NON CONFORMITY REPORT

PLATE HOTEL - 8

Code:	Non Conformity Report_PLATE HOTEL - 8
Revision:	10
Created by:	Leonardo Arcamone & Carmen Riccio
Reviewed by:	Marco Adinolfi
Approved by:	
Date of Approval:

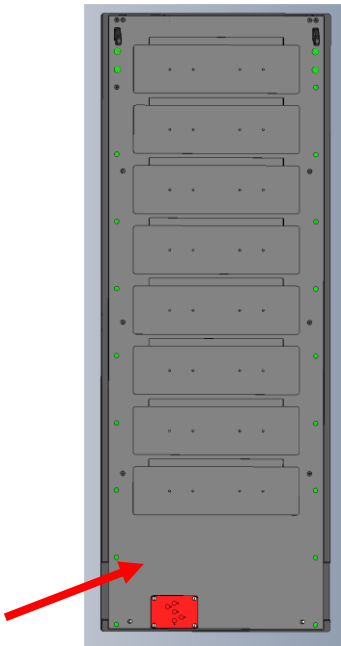
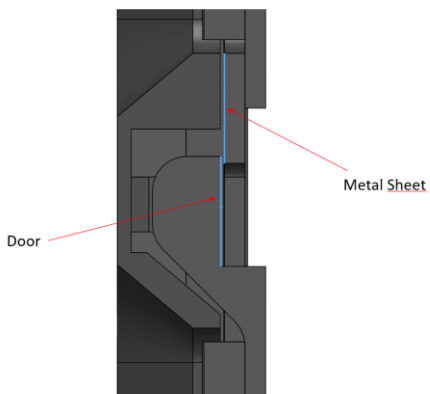
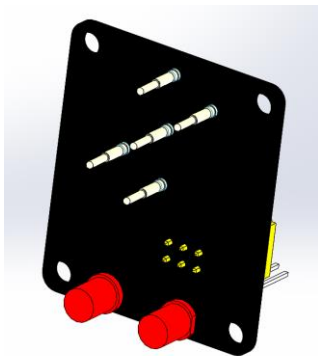
NC #1 - Summary			
Odoo Ref.	Ticket ID #2359		
Issued by	R&D	Issued on	18/12/2024
NC Owner	Ranesh Thanikasalam		
Description of the NC	The customer contacted us reporting that there is no airflow coming out of the humidifier cap when the cap is fully screwed on. If it is unscrewed slightly, airflow can be seen. Video is attached to clarify the issue.		
Serial Number ☐ N/A	2025-3680; 2025-4046		
Severity	Minor		
Containement Actions	New selected O-ring: is OR-34X2.20-NBR70 It protrudes slightly in relation to the metal surface and therefore when closing the cap, it is closed with the O-ring and thus a seal is ensured.

Root Cause Analysis	The refill cap has an O-ring with a thickness of 2 mm, which sits inside a 2 mm deep groove. The figure highlights the groove, which is 2 mm, where the O-ring should be placed.  In details: - In blue the surface where the O-ring is placed - In green the O-ring

When the O-ring is installed, it is positioned below the highlighted surface in the figure above. Therefore, when the cap is screwed on, the O-ring may be not compressed, but instead, contact is made with the metal surface, which causes a leak.

Corrective Actions	No	Identified Action	Responsible	Target Date
	1	Mechanical reworking of the O-ring housing metal part	Ranesh Thanikasalam	To be defined
Supporting Doc	N/A			
Closed on	30/12/2024

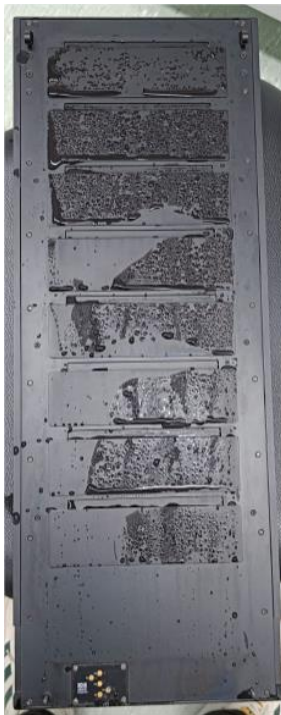
NC #2 - Summary			
Odoo Ref.	Ticket ID #2299		
Issued by	Production	Issued on	06/11/2024
NC Owner	Marco Adinolfi		
Description of the NC	The customer contacted us reporting that the screws (highlighted in green) of the front door came loose and detached from their housing. When the door was sent for RMA to replace these screws, it was noticed that: 1. The screws cannot be fully screwed in because this deforms the sheet metal (indicated by the red arrow), creating an air gap and thus a leakage of approximately 0.7 l/min, which causes the quality tests to fail.

2. The operator has to spend time finding the correct adjustment for these screws, which is currently not a repeatable action but depends on the operator's sensitivity.			
Serial Number ☐ N/A	2218-1008;2218-1009			
Severity	Minor			
Containement Actions	Tighten the fastening screws and then secure them with threadlocker to prevent sheet metal deformation.			
Root Cause Analysis	The sheet metal is very large and thin. If the screws are overtightened, the sheet metal tends to deform and makes contact with the overhead doors, which tend to open and create a small gap.			
Supporting Doc	N/A			
Corrective Actions	No	Identified Action	Responsible	Target Date
	1	 The two blue surfaces require increased clearance. It is feasible to perform mechanical reworking of the door to increase the current gap, which is presently 0.2 mm.	Marco Adinolfi	30/01/25
Supporting Doc	N/A			
Closed on

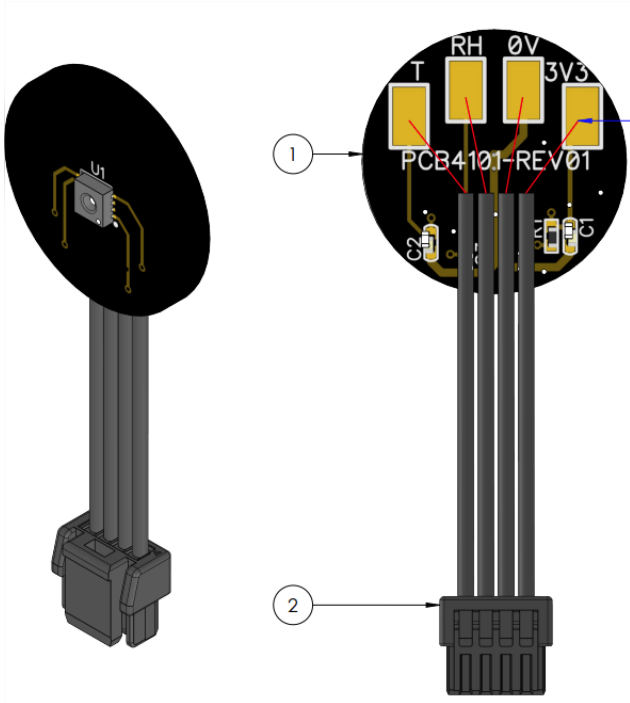
NC Owner	Marco Adinolfi																											
Description of the NC	Non-interchangeability of frontal doors During the OCOPS test, the frontal door of the PLATE HOTEL 1008 was not recognized when placed on the PLATE HOTEL 1009 hard case.																											
Serial Number ☐ N/A	2218-1008;2218-1009																											
Severity	Maior																											
Containement Actions	None																											
Root Cause Analysis	The port is not recognised because the pogo pins are not long enough to make contact with the PCB pads. When the frontal door is mounted on the case, a gap can be seen, which indicates that the pins are not long enough to touch the pads of the PCB5301 Below is a table where different MKH are compared:

<table><tr><th></th><th>MKH 1011</th><th>MKH 1009</th><th>MKH 1009 with 1008 Frontal door</th></tr><tr><td>PCB5301 position vs aluminium sheet</td><td>[0.15-0.2] mm</td><td>[0.10-0.15] mm</td><td>[0.10-0.15] mm</td></tr><tr><td>Gap between the body and the frontal door</td><td>[0.15-0.2] mm</td><td>[0.05-0.10] mm</td><td>0.15 mm</td></tr><tr><td>Pogo Pin protrusion from the body</td><td>[1.3-1.4] mm</td><td>1.16 mm</td><td>1.16 mm</td></tr><tr><td>Min Interference</td><td>1.1 mm</td><td>1.01 mm</td><td>1.01 mm</td></tr><tr><td>Max Interference</td><td>1.25 mm</td><td>1.06 mm</td><td>1.06 mm</td></tr></table>

ensure reliable electrical contact between the door and the enclosure.		
Supporting Doc	N/A			
Closed on

3.1 NC # 11: Humidity sensor broken due to condensation in case of power loss

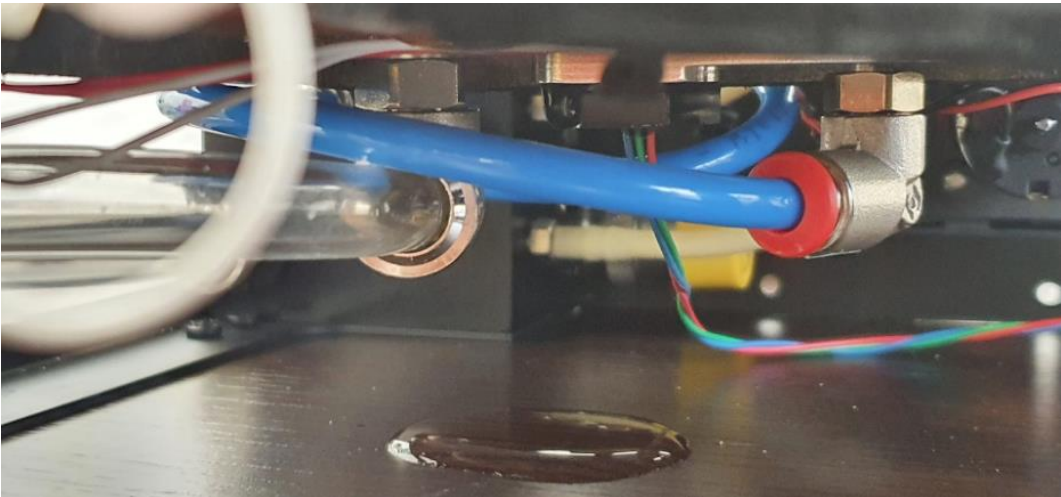
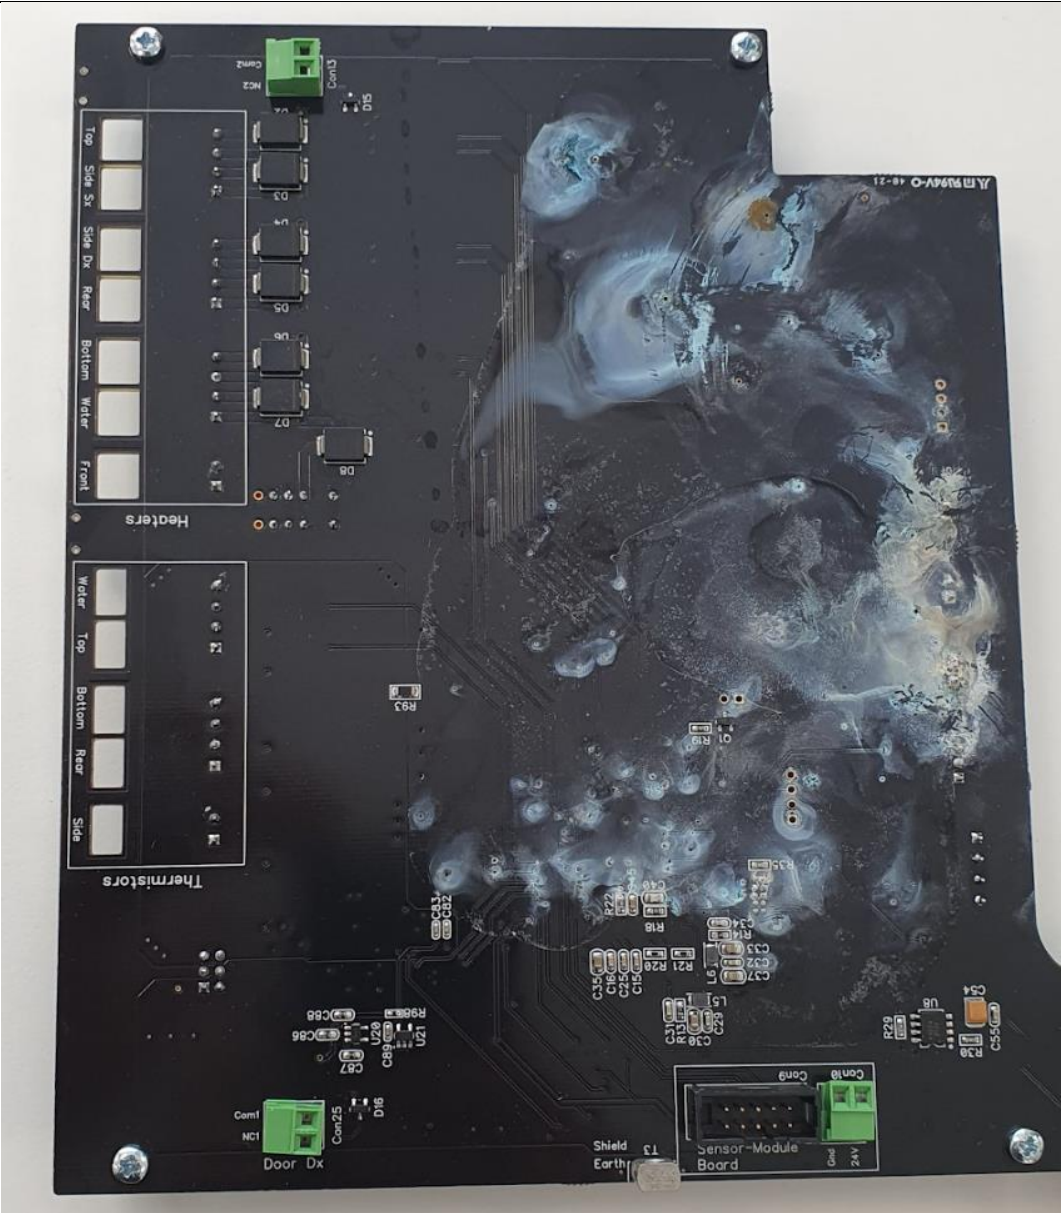
NC #1 - Summary			
Odoo Ref.	Ticket ID#1853		
Issued by	Customer Claim	Issued on	26/04/2024
NC Owner	Marco Adinolfi; Giulio Pasquariello		
Description of the NC	The customer has contacted Customer Care because a lot of condensation has been found inside the PLATE HOTEL 1008, after shutdowns and switch-on of the entire system (PLATE HOTEL + VIVACYTE) due to a software update.

The condensation observed is a consequence of the MKH being shut down without the internal tank emptying first. Consequently, the water drops affected the humidity sensor, which did not show any reading (Humidity: ...), Humidity Status: "Error" and a Humidity

sensor temperature of "-104.00" , means that the reading temperature of the humidity sensor is OUT OF RANGE [0.0 80.0] °C.			
Serial Number ☐ N/A	2218-1008			
Severity	Major			
Containement Actions	A new software version can be developed and installed on all PLATE-HOTEL-8 where the heating elements are always on, even when the system is in "Stand-by" mode. The selective heating of the inner walls can reduce the condensation even if a power loss event happens.			
Root Cause Analysis	The Humidity sensor is not responding as expected. As reported on the datasheet, the Humidity sensor can withstand water drops. The wrong reading is due to a high amount of water on the PCB where the sensor is placed and the absence of a protective coating for the exposed copper pads. Therefore, the root causes of the Humidity Sensor's damage are: - the MKH shutdown without emptying the internal tank first. 			
Supporting Doc	N/A

Corrective Actions	1	Check the current stock of PCB1401-REV01. Keep 40 of them to fulfill at least 10 MICA.	Luigi Pistone	21/05/2024
	2	Ship all PCB1401-REV01 to ELSAV to apply conformal coating.	Luigi Pistone	31/05/2024
	3	Create a separate IST for OKO-MKH-BODY-SENSOR-MODULE	Marco Adinolfi	31/05/2024
	3	Review 'Distinta di Montaggio' for IST 2071 H201-XANTEN-FMB-RH&T-SENSOR and OKO-MKH-BODY-SENSOR-MODULE. Apply changes to IST 2218 OKO-MKH, IST 2115 H201-XANTEN-FMB, IST 2069 H201-XANTEN-SENSOR-MODULE. Add a check for the assembler that the conformal coating is present (requires UV flashlight)	Luigi Pistone	31/05/2024
	4	CREATE OCOPS TEST for OKO-MKH-BODY-SENSOR-MODULE. These contains the tests done on IST 2071 H201-XANTEN-FMB-RH&T-SENSOR, i.e. check against a reference humidity module.	Domenico Izzo	15/06/2024
	5	The PLATE-HOTEL-8 firmware can be modified to read the humidity at start and if it is higher than a threshold the heaters will stay on, even in Stand-by mode = 1. This may reduce condensation and in turn prevent further damage.	Giulio Pasquariello	TBD

4.1 NC # 1: MKH not recognized by computer

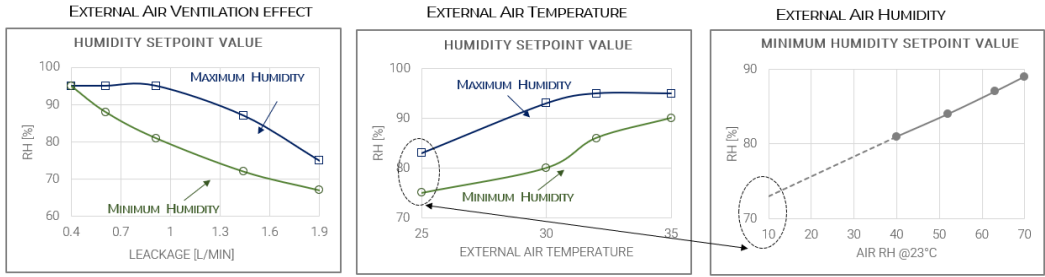
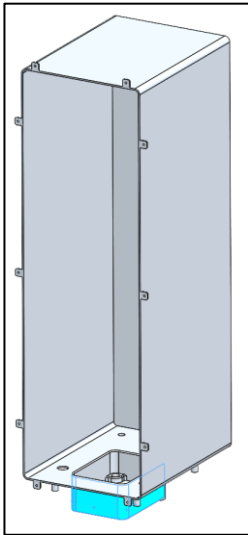
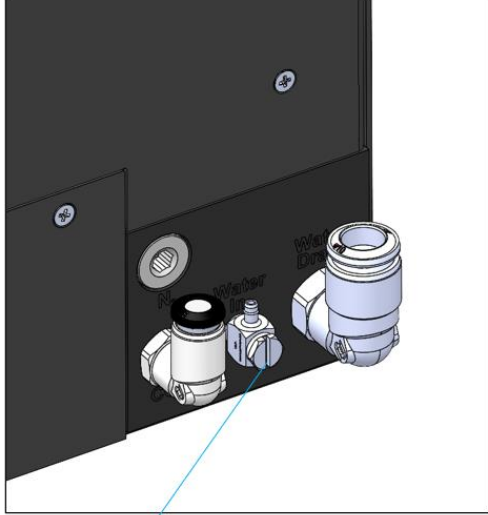
NC #1 - Summary			
Odoo Ref.	☒ N/A		
Issued by	CELLPLY	Issued on	25/07/2022
NC Owner	Marco Adinolfi		
Description of the NC	The MULTI KIT HOTEL is not recognize by the PC.		
Serial Number ☐ N/A	2218-1004		
Severity	Critical		
Containement Actions	Return to the factory for deeper investigation		
Root Cause Analysis	Root Cause: The MULTI KIT HOTEL is not recognize by the PC. This is because the PCB card has been damaged due to a water leak.

Corrective Actions	1	To eliminate the leak, some sealant – PN LOCTITE SI 5331- has been added around the thread of the level sensor. 	Marco Adinolfi	04/11/2022
Supporting Doc	N/A			
Closed on	04/11/2022

4.3 NC # 3: Water Inlet Connector replacement

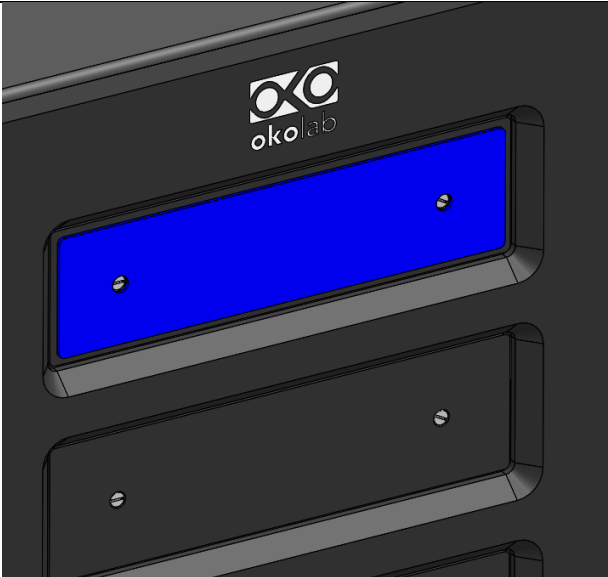
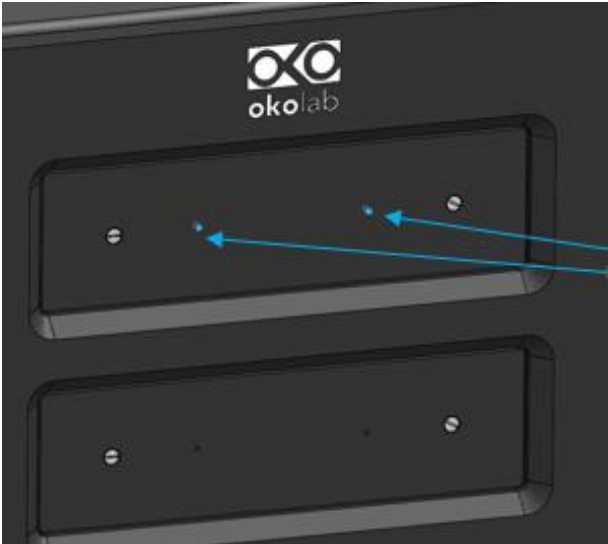
NC #3 - Summary			
Odoo Ref.	☒ N/A		
Issued by	CELLPLY	Issued on	03/10/2022
NC Owner	Marco Adinolfi		
Description of the NC	The silicone tube can be easily detached from current water inlet connector.  Water connector		
Serial Number ☐ N/A	2218-1004		
Severity	Major		
Containement Actions	Return to the factory for deeper investigation		
Root Cause Analysis	Root Cause: the inner diameter of the silicone tube is 3mm while the water inlet connector diameter is 3.2 mm. Because of this, the silicone tube can be easily detached.		
Supporting Doc	N/A

No	Identified Action	Responsible	Target Date
Corrective Actions		Current water inlet connector is replaced by M5LS-1008-1-303.		
	1		Marco Adinolfi	16/02/2024
Supporting Doc	N/A			
Closed on	15/02/2024

4.4 NC # 4: New feet

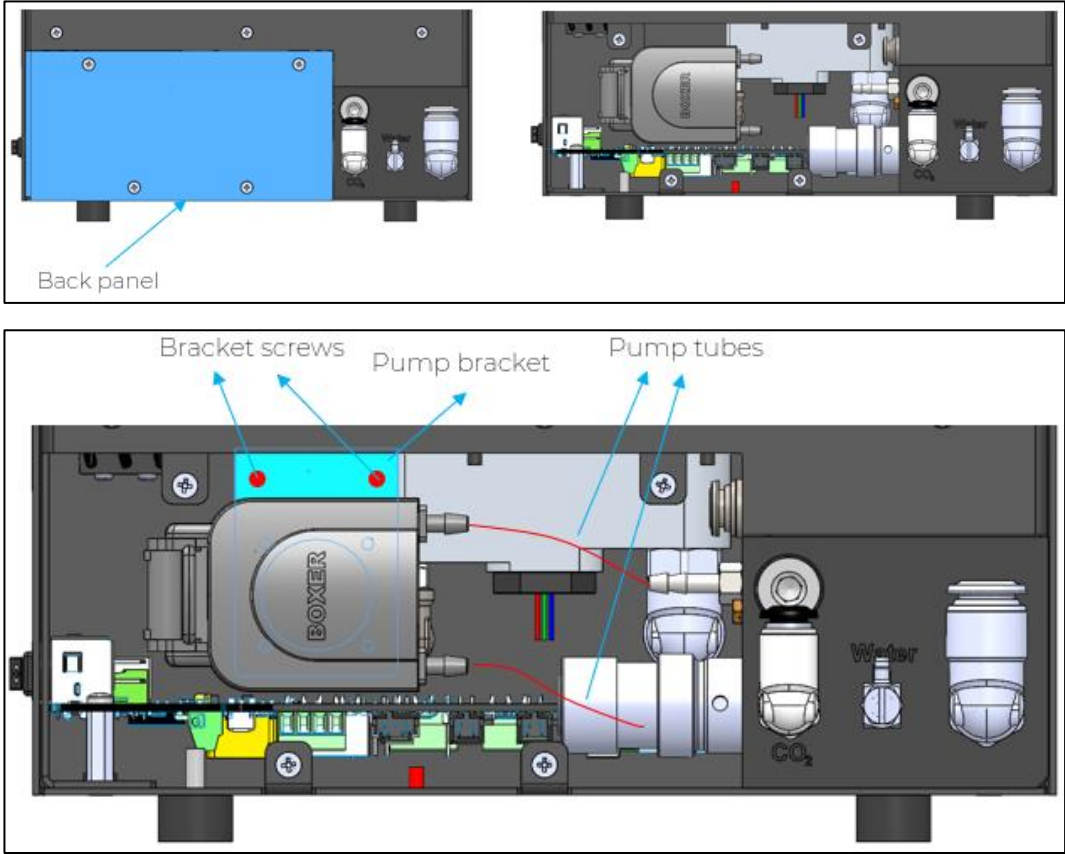
NC #4 - Summary				
Odoo Ref.	☒ N/A			
Issued by	CELLPLY	Issued on	03/10/2022	
NC Owner	Marco Adinolfi			
Description of the NC	Current non-slip feet are damaged when the plate hotel is moved onto the surface without being lifted. 			
Serial Number ☐ N/A	2218-1004			
Severity	Major			
Containement Actions	Return to the factory for deeper investigation			
Root Cause Analysis	Root Cause: the feet are not adequate for the mass of MKH.			
Supporting Doc	N/A			
Corrective Actions	No	Identified Action	Responsible	Target Date
	1	Feet have been replaced with 126-4923, by rs.	Marco Adinolfi	16/02/2024
Supporting Doc	N/A			
Closed on	15/02/2024

4.5 NC # 5: Protection plastic sheets on the tilting doors

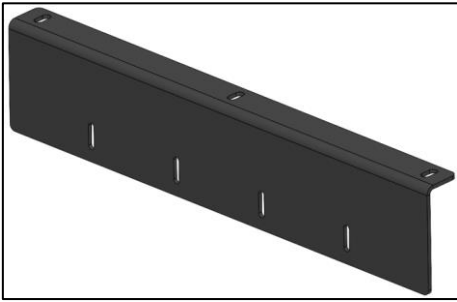
NC #5 - Summary				
Odoo Ref.	☒ N/A			
Issued by	CELLPLY	Issued on	03/10/2022	
NC Owner	Marco Adinolfi			
Description of the NC	All frontal doors are made by black anodized aluminium. Scratches on frontal doors due to the arm entering the plate hotel.			
Serial Number ☐ N/A	2218-1004			
Severity	Major			
Containement Actions	Return to the factory for deeper investigation			
Root Cause Analysis	Root Cause: Since frontal doors are made by black anodized aluminum, they are easily scratched by the arm entering the plate hotel.			
Supporting Doc	N/A			
Corrective Actions	No	Identified Action	Responsible	Target Date
	1	Apply anti-scratches adhesive tape on each door (blue highlighted) in order to protect the doors.	Marco Adinolfi	16/02/2024

Material: tape Surface finishing: smooth Color: black Two threaded holes will be added on the door to eventually screw in a plastic sheet. 		
Supporting Doc	N/A			
Closed on	15/02/2024

4.6 NC # 6: Easy access to the Pump for replacement (solution #1)

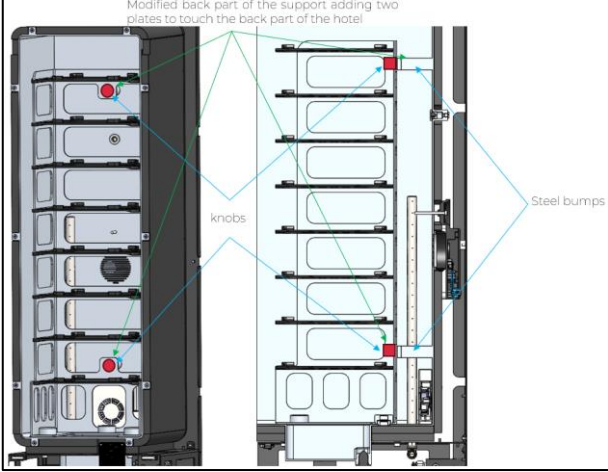
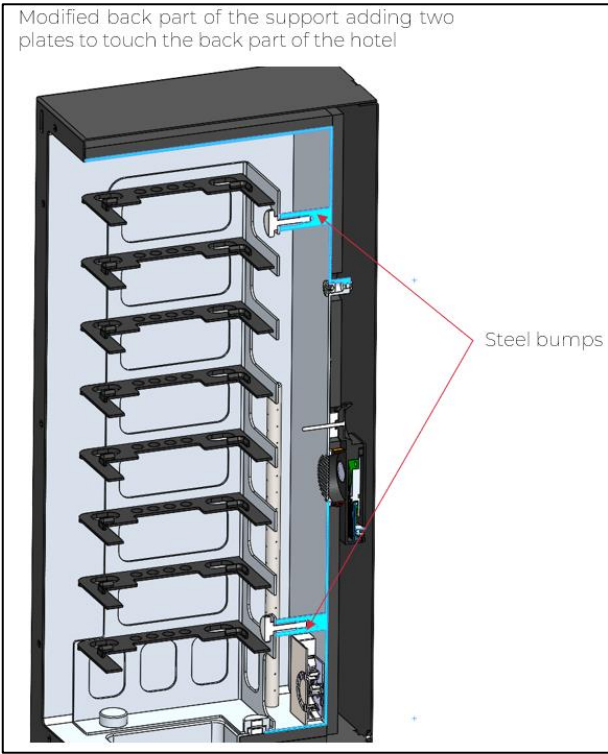
NC #6 - Summary			
Odoo Ref.	☒ N/A		
Issued by	CELLPLY	Issued on	03/10/2022
NC Owner	Marco Adinolfi		
Description of the NC	The pump is mounted inside the plate hotel. It is not possible to substitute the pump for the customer because of limited access to the pump fixings. The bracket of the pump is part of the internal frame. 		
Serial Number ☐ N/A	2218-1004		
Severity	Major		
Containement Actions	Return to the factory for deeper investigation

Root Cause Analysis	Root Cause: access to the pump fixings is quite limited and this makes pump replacement very hard for the customer.			
Supporting Doc	N/A			
Corrective Actions	No	Identified Action	Responsible	Target Date
	1	The steps to substitute the pump become: 1. Unscrew and remove back panel 2. Detach the two pump tubes 3. Unscrew pump bracket 4. Detach pump connector and remove pump 5. Connect new pump connector 6. Screw the pump bracket 7. Connect the two pump tubes 8. Screw the back panel The substitution would be easy without charging on production costs Pump is still inside the PLATE-HOTEL chassis.	Marco Adinolfi	16/02/2024
Supporting Doc	N/A			
Closed on	15/02/2024

4.8 NC # 8: Repeatability of support internal position

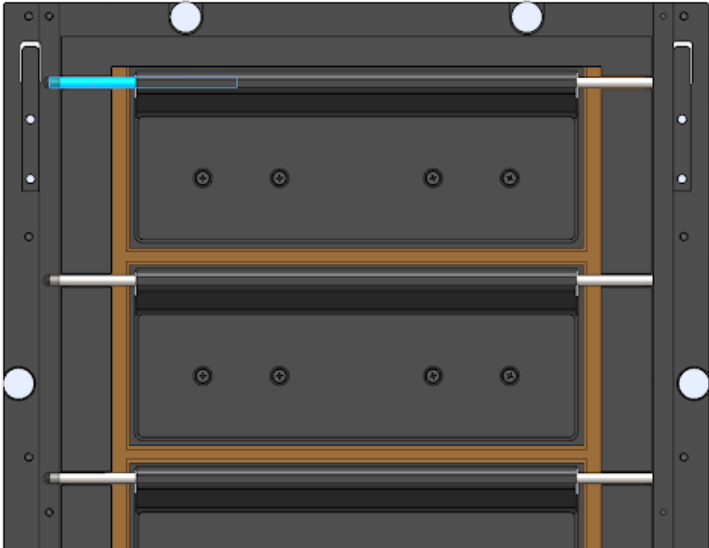
NC #8 - Summary				
Odoo Ref.	☒ N/A			
Issued by	CELLPLY	Issued on	03/10/2022	
NC Owner	Marco Adinolfi			
Description of the NC	The mounting bracket touches the walls on x direction and has a rotation on y direction due to the support positioning. Because of that, support internal position is not repeatable.			
Serial Number ☐ N/A	2218-1004			
Severity	Major			
Containement Actions	Return to the factory for deeper investigation			
Root Cause Analysis	Root Cause: the mounting bracket touches the walls on x direction and has a rotation on y direction due to the support positioning. Because of that, support internal position is not repeatable.			
Supporting Doc	N/A			
Corrective Actions	No	Identified Action	Responsible	Target Date
	1	Add two steel bumps on the back part of the hotel and two plates on the support working as hard stopping. Mounting bracket back surface and steel bumps will be in contact. Furthermore, two knobs (red highlighted) are added to screw the mounting bracket to steel bumps and fix the bracket to the hotel.	Marco Adinolfi	16/02/2024

Modified back part of the support adding two plates to touch the back part of the hotel  Modified back part of the support adding two plates to touch the back part of the hotel 		
Supporting Doc	N/A		
Closed on	15/02/2024
